Contract #: 04-0120F4Cty: SF/ALA Rte: 80 PM: 13.2/13.9File #: 69.25B**QUALITY ASSURANCE -- NON-CONFORMANCE REPORT****Location:** Changxing Island, Shanghai, P.R. China**Report No:** NCR-000687**Prime Contractor:** American Bridge/Fluor Enterprises, a JV**Date:** 26-Feb-2010**Submitting Contractor:** Zhenhua Port Machinery Company, Ltd (ZPMC), Changxing Island**NCR #:** ZPMC-0654**Type of problem:**

Reference Description: Missed UT indications by QC on Segment 5BW on Side to Edge Panel Welds**Description of Non-Conformance:**

Job Name: SAS Superstructure
Document No: 05.03.06-000644

WELD NUMBER: CA019-001

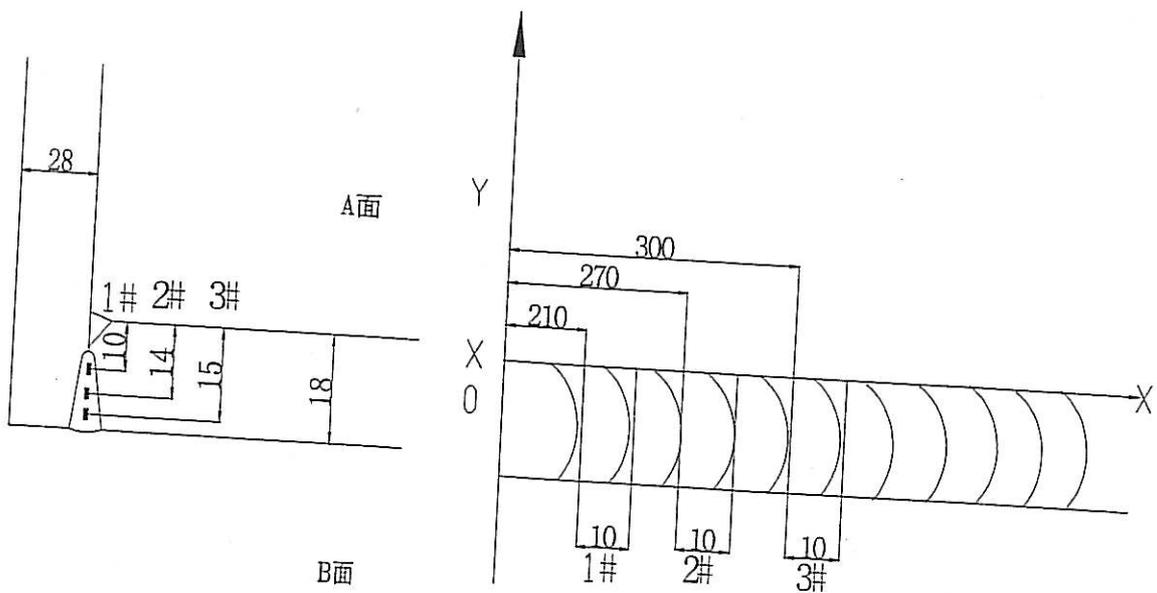
Rejected indication found by ultrasonic inspection is less than the maximum allowance aggregate length.
(UT探伤发现的缺陷总长度小于最大允许长度。) CA019-001

1. Did not clear the weld pass completely in time.

1. Gouge or grind from nearer side from metal edge ($D \leq 0.65T$, "D" is depth of defects, "T" is thickness of metal) to remove all defects;

2. Follow repair WPS for joint preparation, preheat, and weld deposit;

3. Verify with VT no defects remain in the weld joint prior to welding;

4. Grind the repaired area flush with base metal or the adjacent weld;

5. Check the welds according to the working drawings.
